REQUEST FOR ADDITIONAL INFORMATION
Environmental Planning and Assessment Regulation 2000 - Clause 54

Development Application No: 1227/2019/DA-M

Property: 12 Francis Street, Minto, 14 Francis Street, Minto, 16 Francis Street, Minto, 121 Minto Road, Minto

Development: Demolition of existing dwellings and construction of a multi dwelling housing development consisting of 23 dwellings and basement car parking under the provisions of State Environmental Planning Policy (Affordable Rental Housing) 2009

Shadow Diagrams

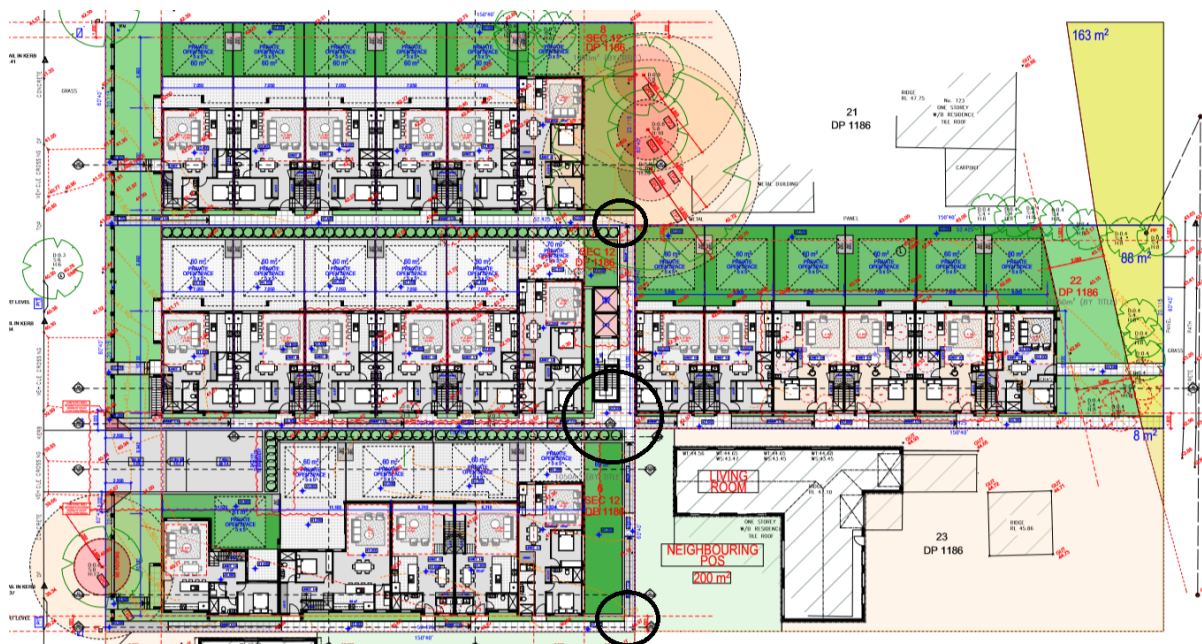
44. The shadow diagrams do not demonstrate the current solar access received by the adjoining impacted dwellings. The amount of sunlight lost is required to be taken into account as well as the amount of sunlight retained.

45. The shadow diagrams do not include all overshadowing impacts on the adjoining impacted residential allotments, which is not an accurate assessment of the solar access received. For example, the shadow diagrams for 18 Francis Street indicate that no overshadowing is occurring at 1pm, however, overshadowing would be caused from the existing dwelling, boundary fencing and development on 20 Francis Street. Revised shadow diagrams must consider overshadowing by fencing, roof overhangs and adjoining development when assessing the overshadowing impacts to the adjoining residential allotments.

46. The shadow diagrams are required to be revised to include the location of clothes drying areas of adjoining residential development and include all structures in the rear of the dwelling at 18 Francis Street.

Retaining Walls

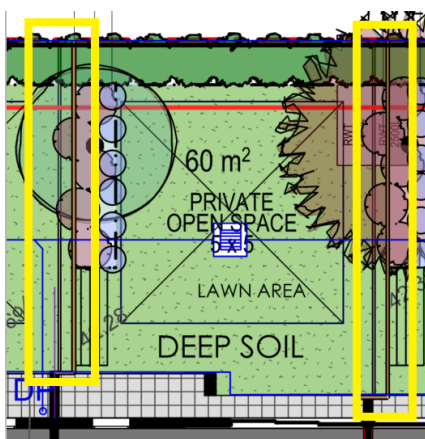
51. In addressing Part 2.12 of Council's (Sustainable City) Development Control Plan 2015, the response from The Planning Hub states that 'all proposed retaining walls are setback over 0.45m off the property boundaries'.

52. Timber sleeper retaining walls are proposed on the revised plans on the higher side (eastern side) of the site due to the proposed cut of 420mm maximum. Further, there is also a 'drop edge beam down to NGL'.

53. Council does not support any retaining structures on the property boundary without adjoining owners consent, and maintenance easements on the adjoining allotment.

54. Provide revised plans that does not including any structures on the property boundary. In accordance with Part 2.12 of Council's (Sustainable City) Development Control Plan, no retaining walls are to be within 450mm of the property boundary.

55. If retaining walls are to be proposed, they must be in accordance with Part 2.12 of Council's (Sustainable City) DCP 2015 and must demonstrate that they do not obstruct the upstream overland flow paths. All plans, including the landscape plan, must show all retaining structures.
